SAN FRANCISCO PLANNING DEPARTMENT

MEMO

TO: **Architectural Review Committee (ARC) of the Historic Preservation Commission**

RE: Review and Comment for 856 Market Street
Case No. 2015-008484PTA

856 MARKET
PROPOSED ELEVATION

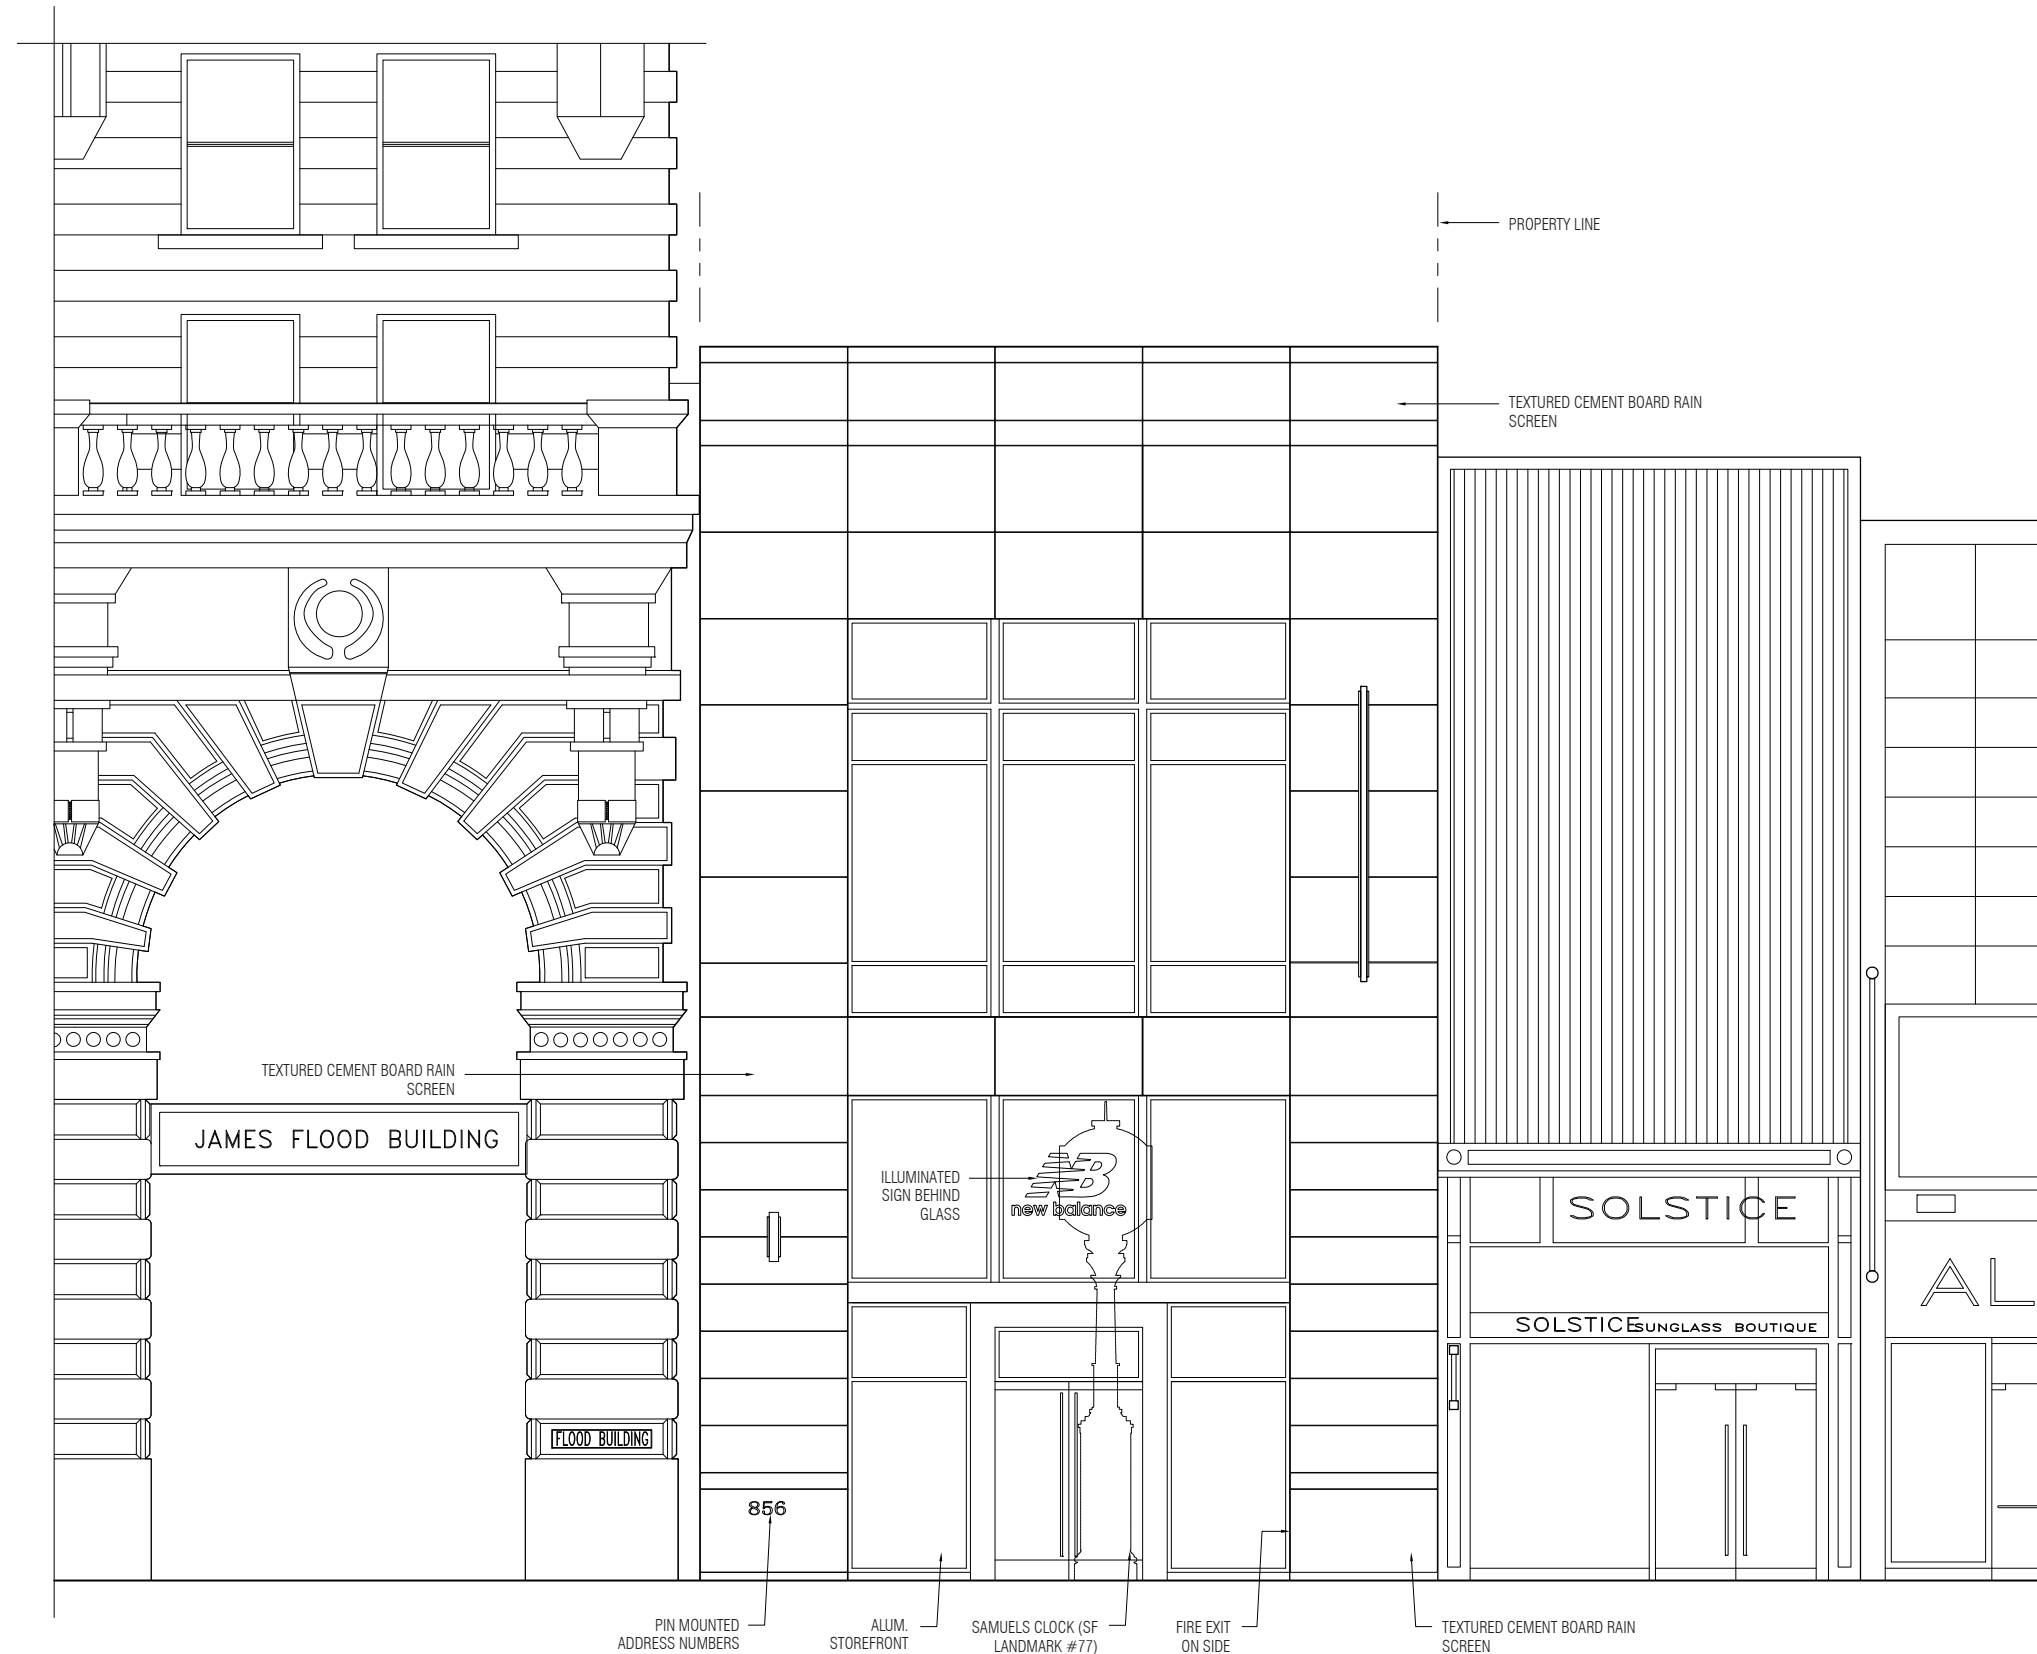
The new fenestration and cladding will introduce a two-part vertical composition with the horizontal band that separates the two window bays breaking up the lower and upper portions of the building. The horizontal band between the windows relates to the interior floor levels although the upper floors do not extend to the façade.

1. Does the proposed massing and composition and scale appear compatible with the character of the surrounding buildings on Market Street and with the District?

Structures in the District display cladding materials that are often rusticated at the ground and second story to express the mass and weight of structures, and have textural variation and a sense of depth. The Department is concerned that the proposed cladding material lacks the textural qualities in both finish and installation to relate to the District. While the plan and rendering views depict numerous joints, these are dry joints (3/8") without sufficient depth to add texture to the façade. Further, the size and shape of the panels, which make sense at the base of the building, become less ideal at the upper portion of the façade. There are also concerns about how the material will be detailed where it returns at the window jambs and recessed storefront and its durability at such a high traffic section of Market Street. The Department believes that further construction details for the proposed cladding system need to be provided and that these details need to demonstrate the material's ability to appropriately reference the qualities of cladding materials characteristic of the District. If the proposed material cannot demonstrate these qualities, then an alternative cladding material should be proposed.

2. Are the proposed cement board panels (Swiss Pearl), powder coated aluminum window and storefront frames, and painted metal surround at the entry appropriate for and compatible with the KMMS District?

3. Does the simple and contemporary detailing and ornamentation of the proposed new facade appear compatible with the KMMS District?

- *Given the rather small height of the building, a two-part vertical composition appears appropriate.*
- *The recessed storefront provides an intimate scale at the street that appears appropriate.*

- *The proposed cement board panel system needs to demonstrate that it can be installed and detailed in a manner that appropriately references cladding materials typical of the District. If this cannot be demonstrated, then an alternative cladding system should be proposed. The choice of cladding material is particularly important at the base of the building where its appearance and durability will be most tested on this high traffic stretch of Market Street.*

- *The cladding material should have characteristics, such as rustication, band coursing, profiles, and texture that are typical of such materials within the District. Typical cladding materials within the District include terra cotta, stone, brick, and stucco.*

- *The bulkhead (storefront base) should be clad with stone or tiles and be increased in height to comply with the Department's Draft Design Standards for Storefronts in Article 11 Districts (Storefront Standards).*

- *The aluminum window and storefront systems and metal storefront surround are appropriate.*

- *The simple and contemporary design of the façade appears compatible with the District.*

SIGNS

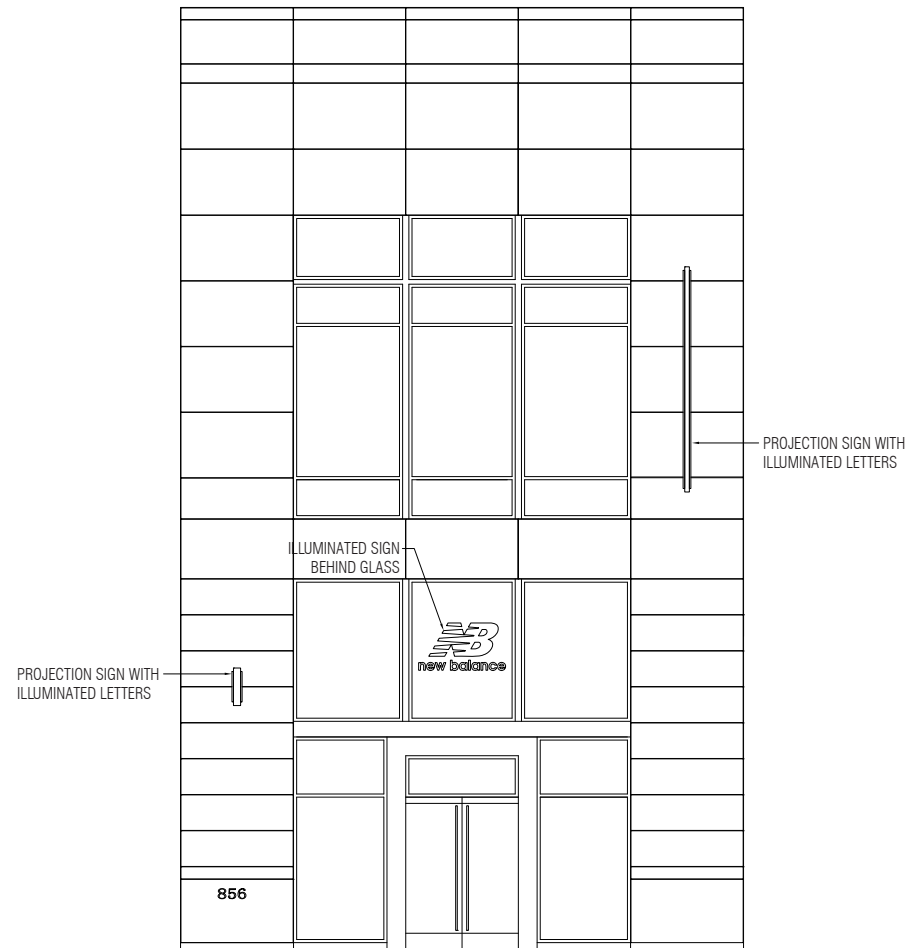
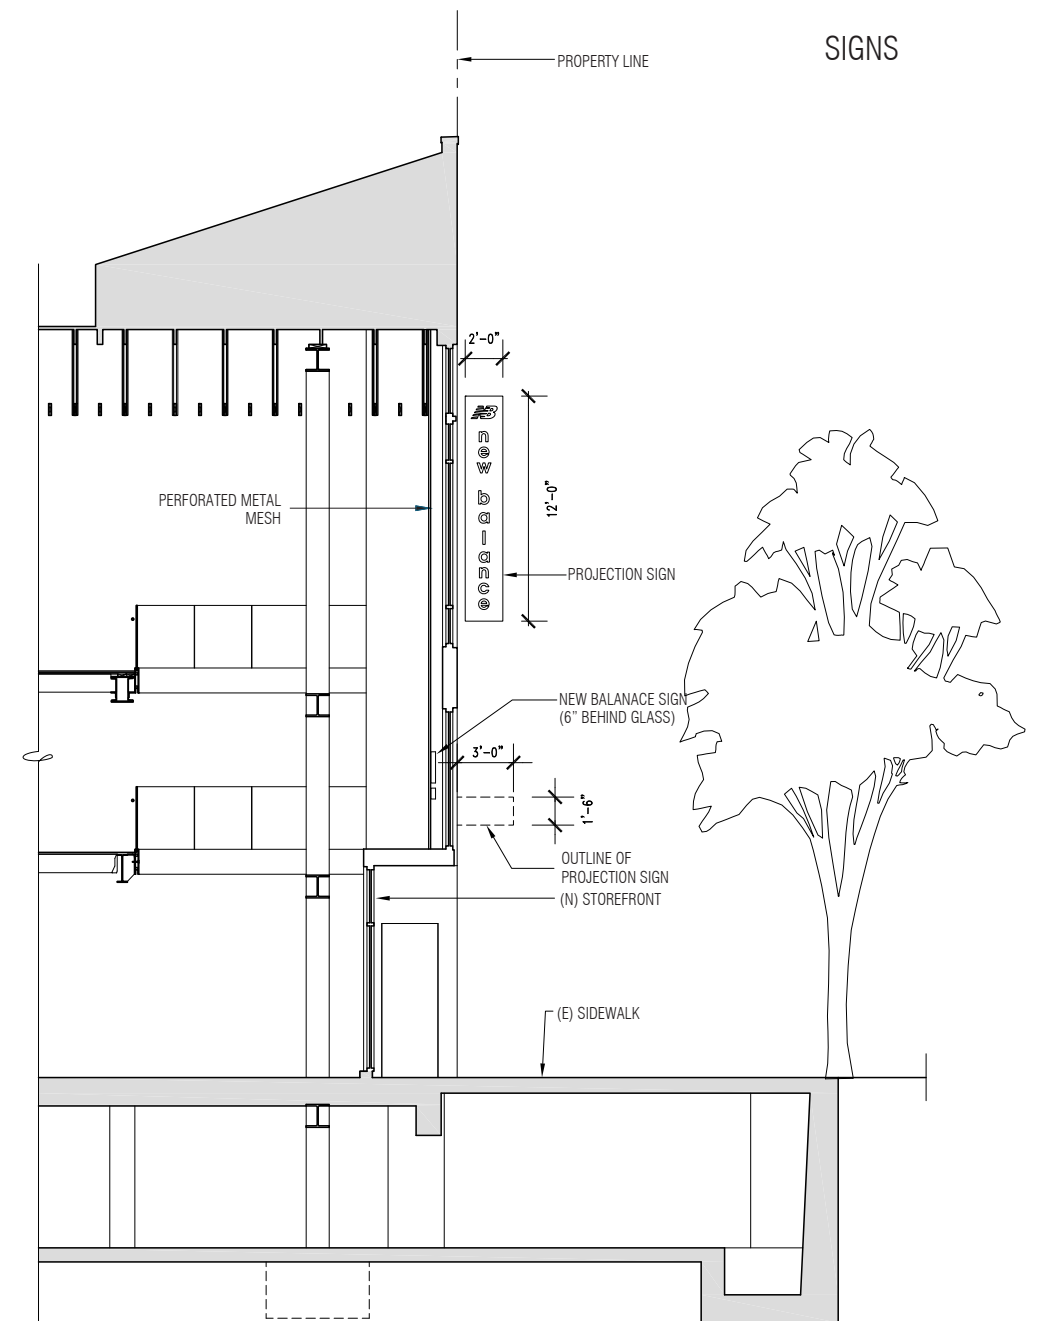
The project proposes to introduce a thin blade sign, above the ground floor level. The new blade sign will be of aluminum material and will be approximately 14.5' in height. While the new blade sign is consistent in terms of material, illumination and method of attachment, it is not consistent with the Department's Sign Guidelines in terms of size and location. Specifically, the guidelines call for projecting signs to relate to the pedestrian scale and not be located at a height above the lintel of the corresponding storefront. In this particular case, as the building is fully occupied with a single tenant and is situated on this high traffic stretch of Market Street, the Department is generally comfortable with the location of the sign although we think that it should be reduced in size to a maximum of 12' in height. In order to provide a pedestrian-scaled sign, the Department believes that an additional small blade sign should be placed lower on the façade at the storefront level.

- *That the proposed large blade sign be reduced in size to a maximum of 12' in height to better relate to the adjacent window opening.*
- *That an additional small blade sign be placed at the storefront level.*
